Landscape Review Committee
Hybrid In-Person & ZOOM Online Meeting
Monday, May 12, 2025 - 12:00 PM

DATE: May 12, 2025
TO: Landscape Review Committee Members
FROM: Taylor Graybehl, Senior Planner
SUBJECT: Landscape Plan Review Application (L 8-25)

DOCKET: L 8-25 (Landscape Plan Review)

REQUEST: Approval of a street tree plan, and a landscape plan review for Tract A, in Elysium Subdivision, (Ordinance No. 5116, dockets ZC 1-22, PD 1-21, and S 1-21). The applications are submitted to address the conditions of approval.

Figure 3. Street Tree Plan

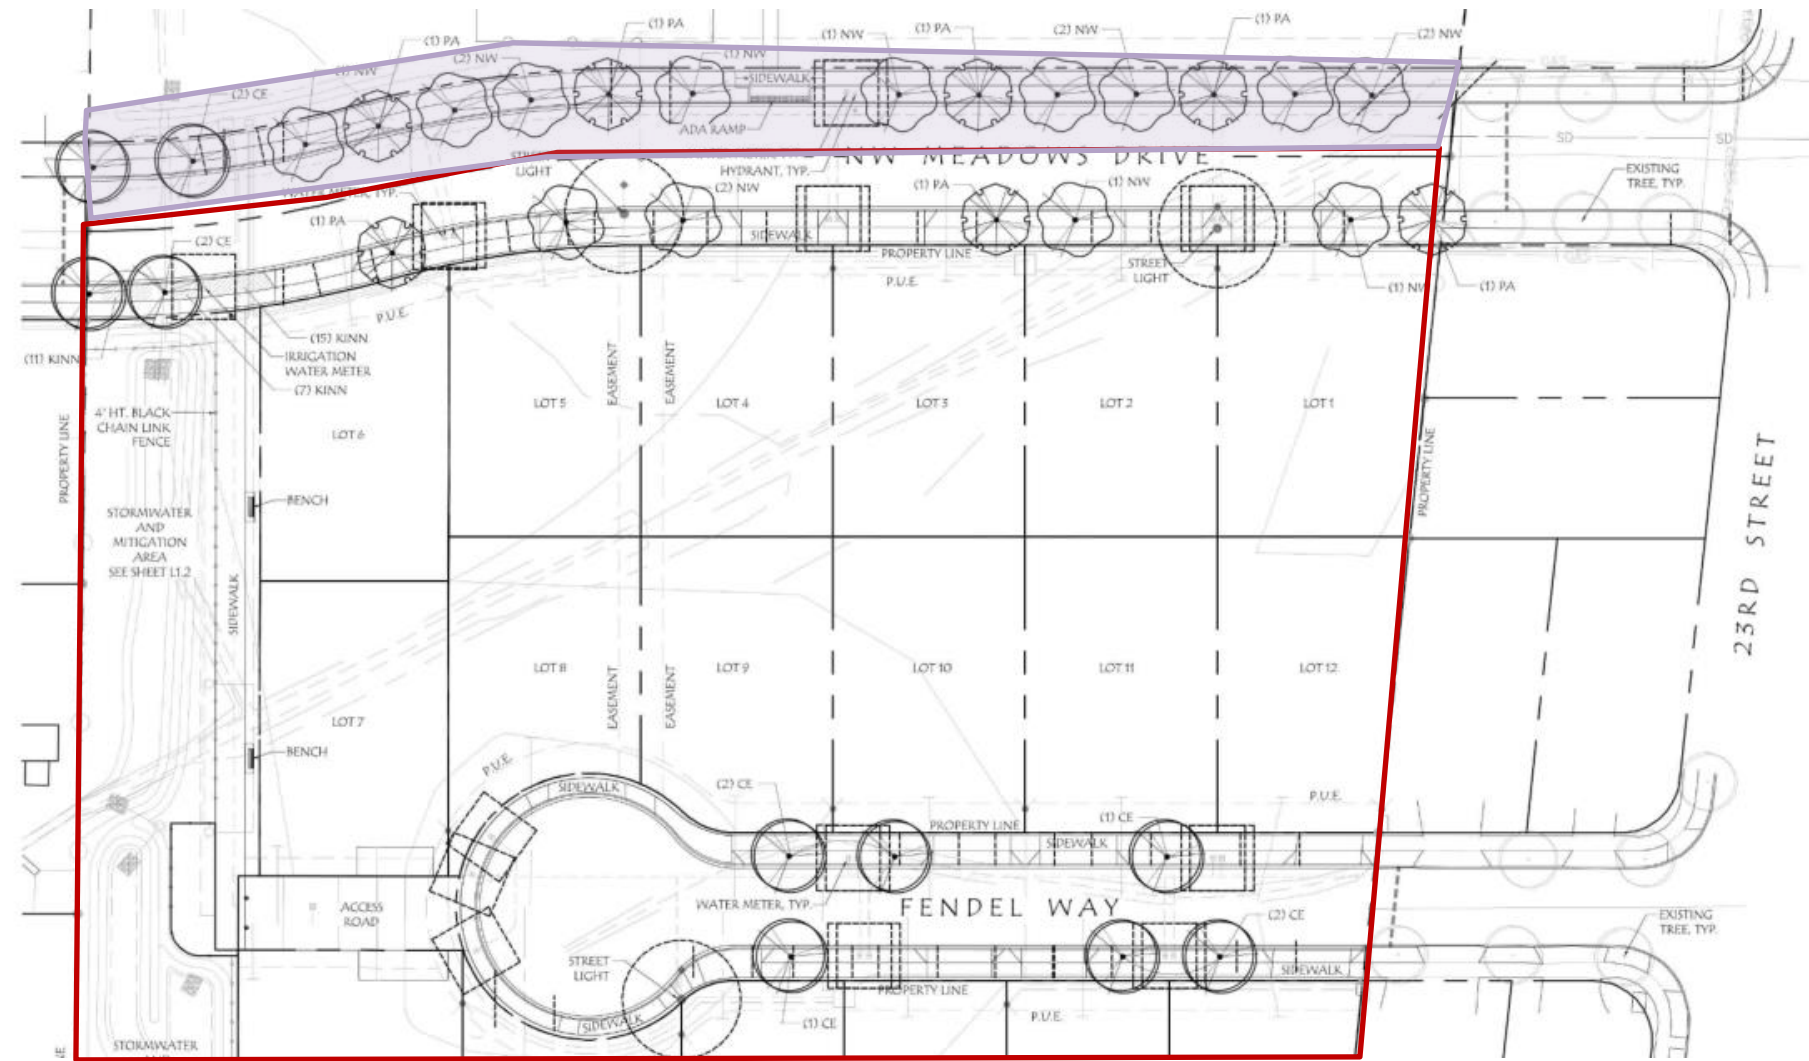
The street tree plan (L1.1) outlines the proposed locations of street trees within the right-of-way of NW Meadows Drive and NW Fendle Way. However, only the eastern portion of NW Meadows Drive and NW Fendle Way falls within the required street tree plan. The western portion of NW Meadows Drive falls outside the subdivision and is not subject to the requirements of Chapter 17.58.

The plan includes dashed lines surrounding streetlights, driveways, and utilities to show the minimum required buffering distance for the placement of street trees. In addition, the applicant included a letter requesting a variation to the minimum spacing and even spacing requirements of MMC 17.58.090(C).

As seen on the plans, the number of trees that can be placed is limited due to required buffering; thus, planting street trees does not meet the minimum spacing requirements of (MMC 17.58.090(C)). The applicant has identified the need for the variation due to “the location of the various utility services, streetlights, and driveways, and the required setbacks from those items make it impossible to space the street trees evenly and as frequently as intended in the standards.” The applicant has proposed to mitigate the spacing concerns in the following ways:

8. Street trees shall be centered between the back of the curb and the front of the sidewalk. (MMC 17.58.090(D))
9. Street trees shall be planted to spacing standards established in MMC Section 17.58.090(E), not to be planted within:

- c. Twenty (20) feet of street light standards or street intersections.
 - d. The Public Works Director may grant variations to planting spacing standards.

Figure 4. Tract A Landscape Plan

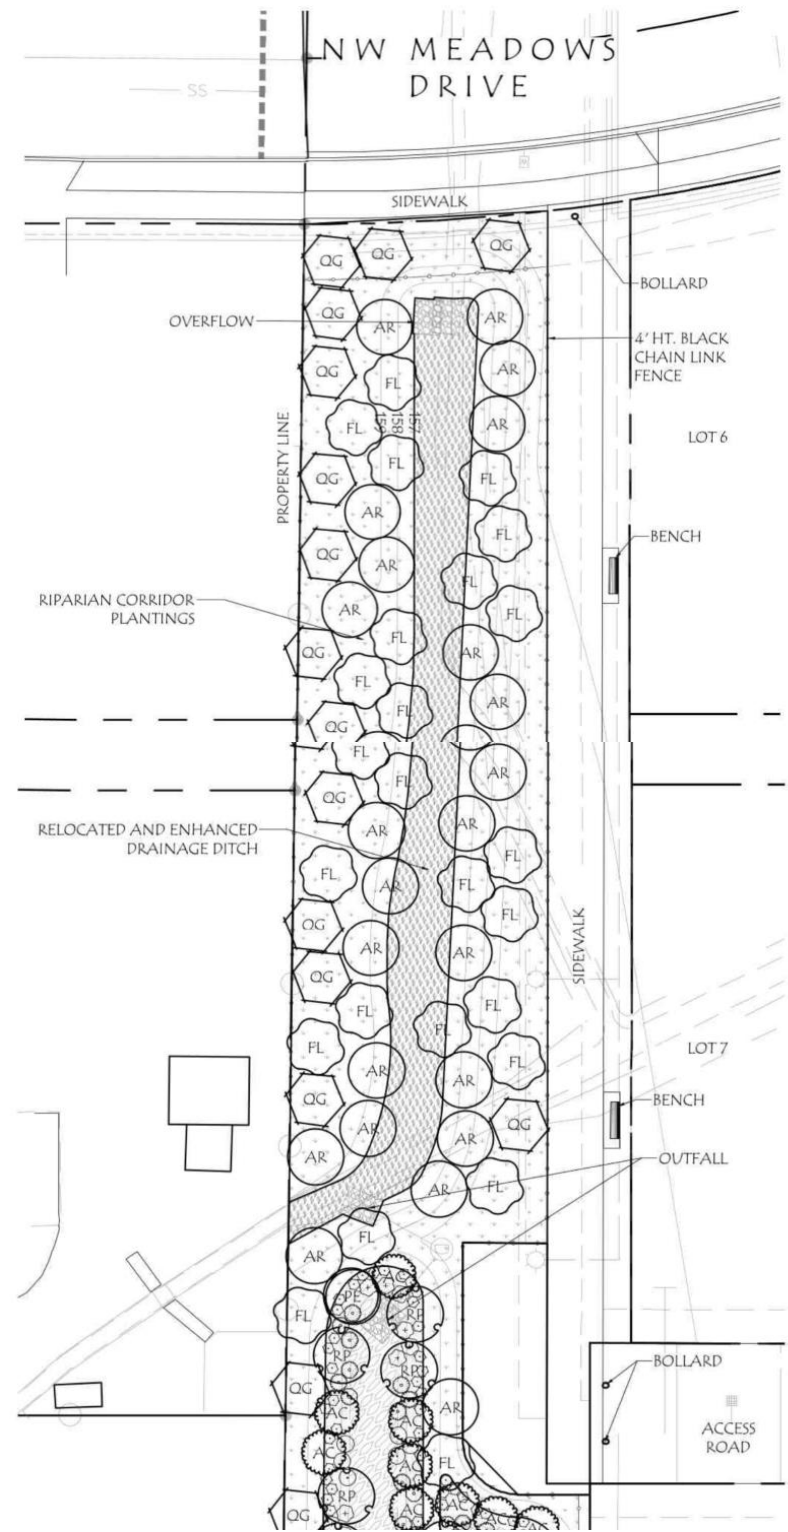
The condition of approval #38 for ZC 1-22, PD 1-21, and S 1-21 requires the submission of a Landscape Plan for review and approval by the Landscape Review Committee prior to the approval of the final plat. The Landscape Plan is to include a pedestrian path to Jay Pearson Neighborhood Park and amenities within "Tract A" of the subdivision. The proposed landscape plan does not comply with the conditions of approval, as outlined in Ordinance No. 5116, and alterations are required as specified in the conditions of approval for this application.

- (a) **Complies.** Two benches are provided.
- (b) **Satisfied with Condition.** The plans indicate a 4' H black chain link fence; which does not meet the condition. The applicant will be required to revise the fence type to one that meets this standard.
- (c) **Satisfied with Condition.** The plans indicate irrigation lines to dark brown tubing with gray striping. Revise plans to reflect exposed irrigation lines to be black or camouflaged from the public view.
- (d) **Satisfied with Condition.** The plans do not indicate the design of the lighting fixture or the expected foot candles on the adjacent residents. It is not possible to determine if this standard will be met. Revised plans are required that clearly demonstrate the light fixture design, showing that the lighting is shielded to minimize impact on adjacent residents.

Satisfied with Condition. The proposed connection is approximately 5' wide, extending from the sidewalk along the western portion of the subdivision to Jay Pearson Neighborhood Park. This connection was required as part of the Planned Development approval as an amenity proposed by the applicant to justify the Planned Development. To be approved by the Planning Director, the applicant must expand the width of the proposed connection to 10'.

CONDITION OF APPROVAL #1: Prior to final plat, the applicant shall submit a revised landscape plan in compliance with the conditions of approval of Ordinance No 5116. The landscape plan shall be revised in the following manner:

- a. Fences in Tract A shall be a split rail open black fencing or other similarly aesthetically pleasing fence style.
- b. Irrigation lines shall be black or noted to be camouflaged from public view.
- c. Provide the design of light fixtures, showing that lighting is shielded to minimize impact on adjacent residents.
- d. Expand the width of the pedestrian connection to Jay Pearson Neighborhood Park to ten (10) feet.

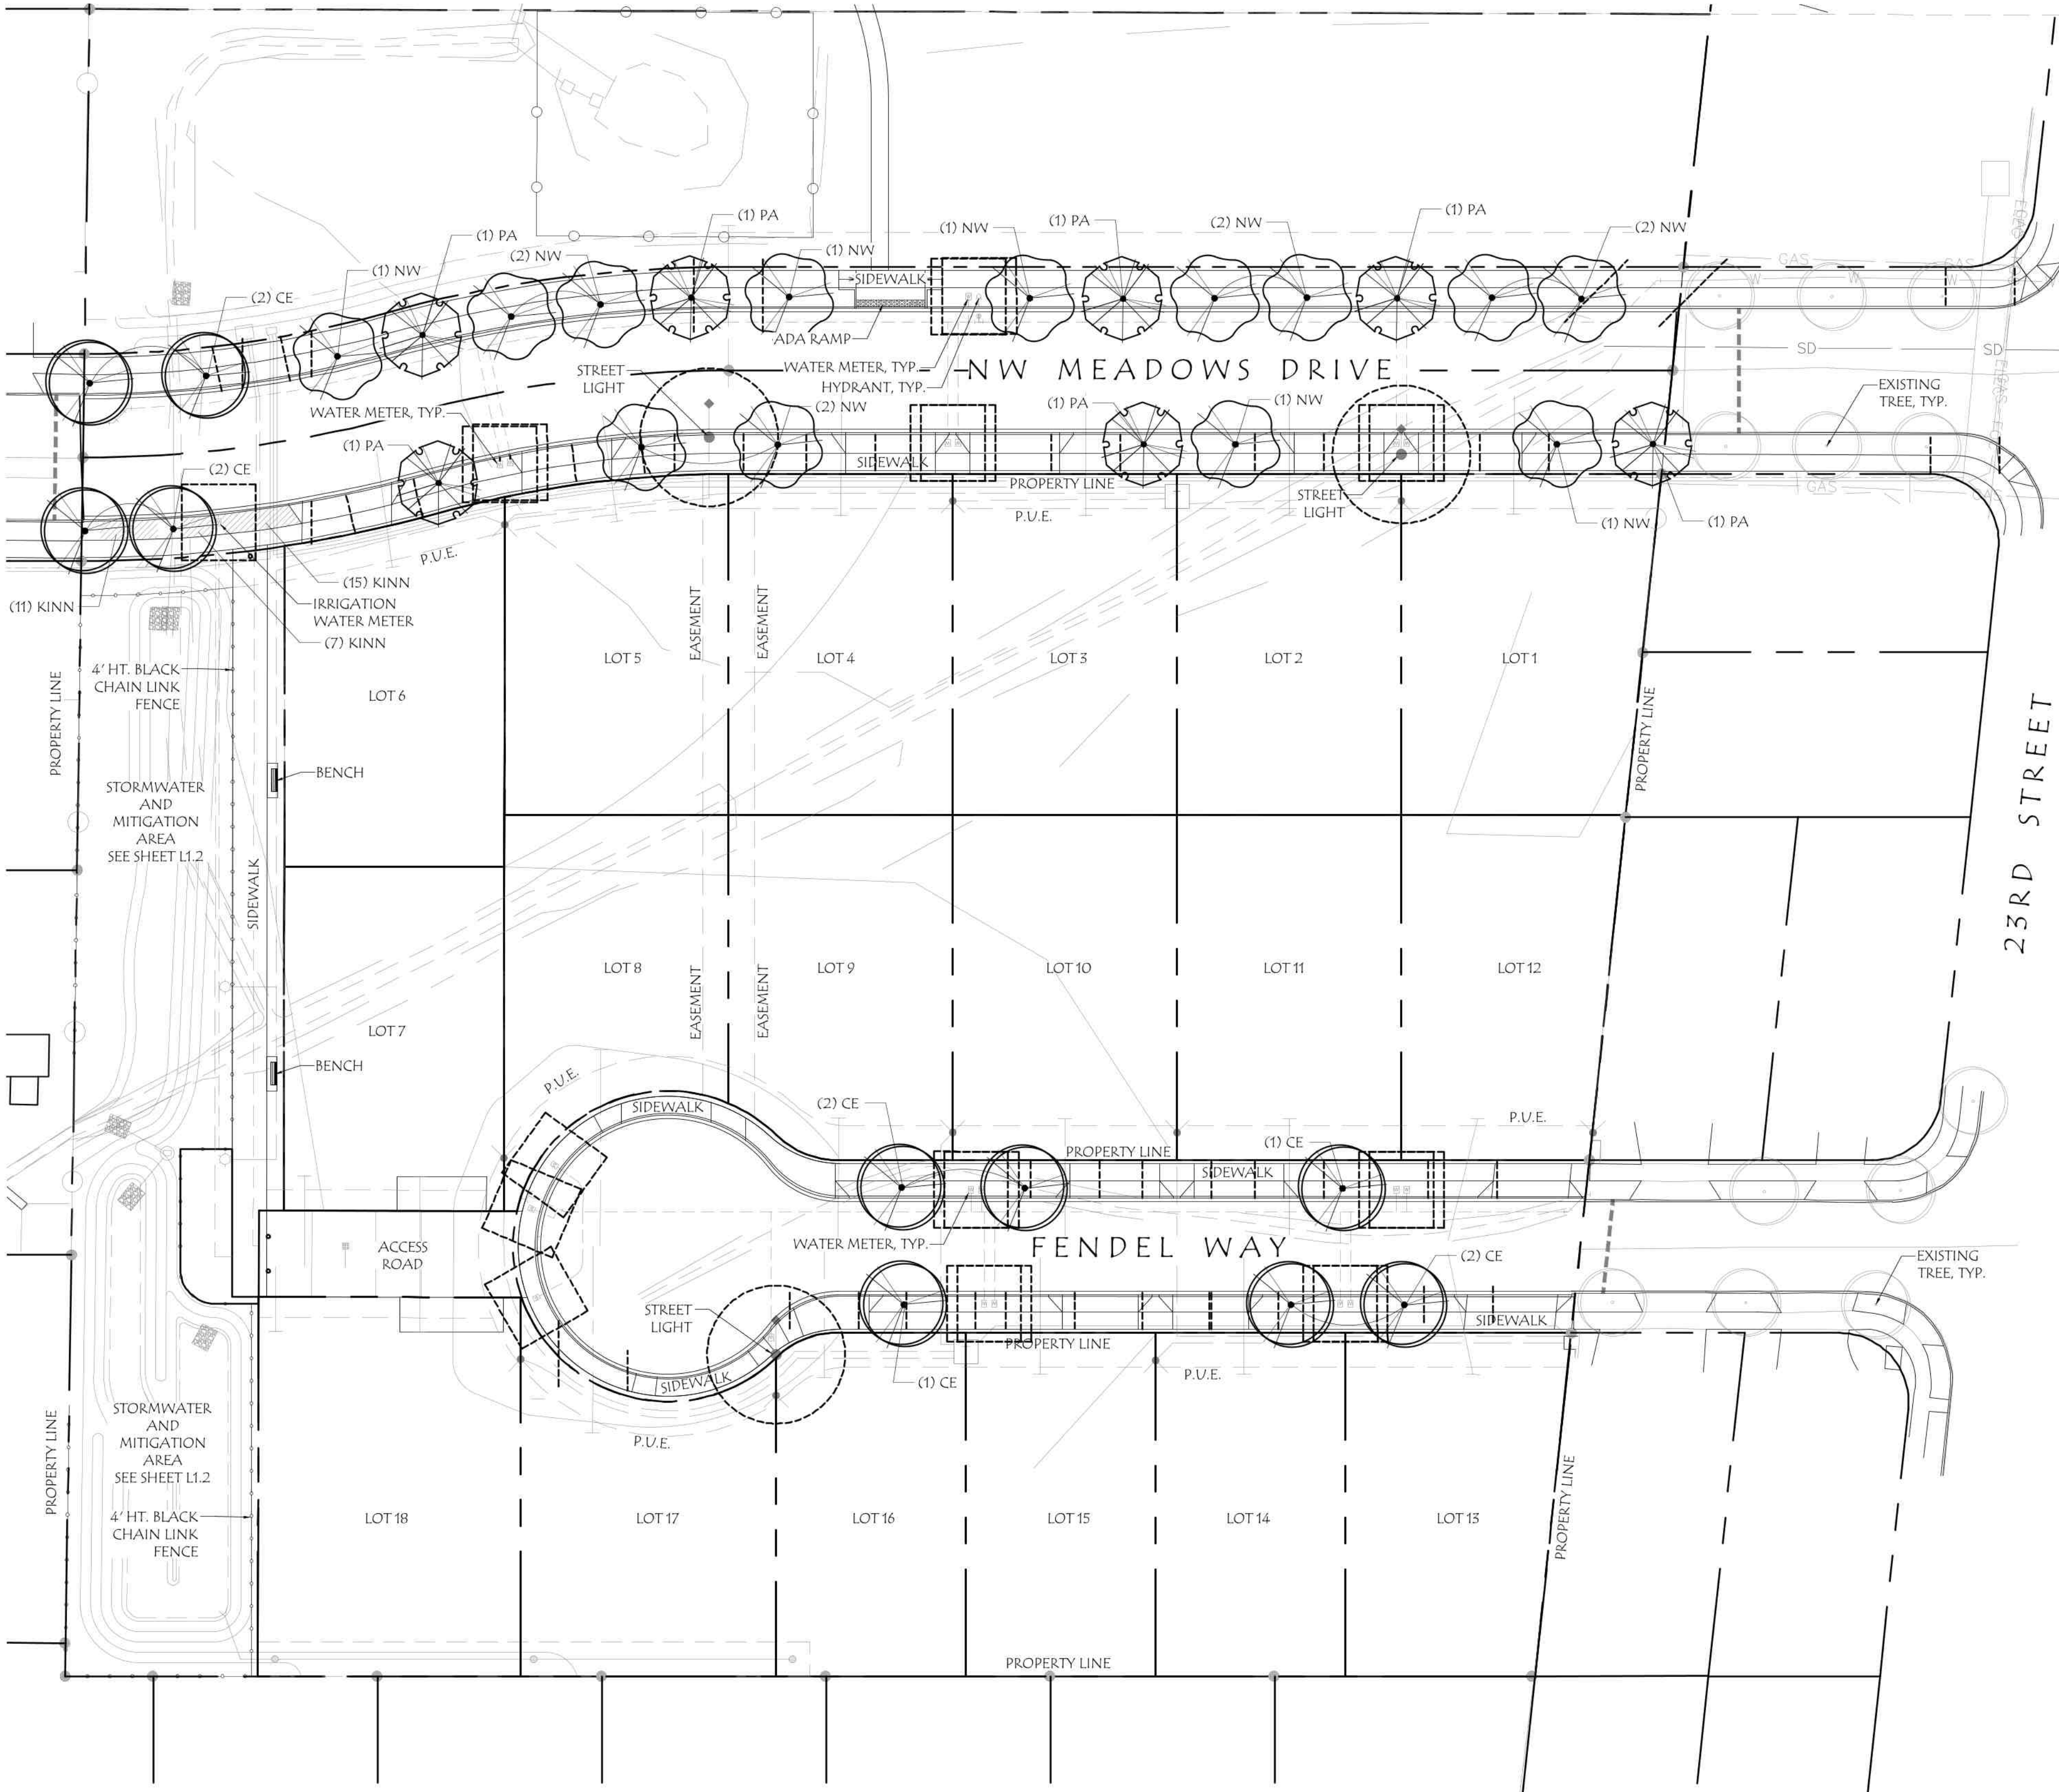
Please ensure that no trees are planted within 10 feet of transformers or utility vaults, and maintain a minimum clearance of 20 feet from street lights.
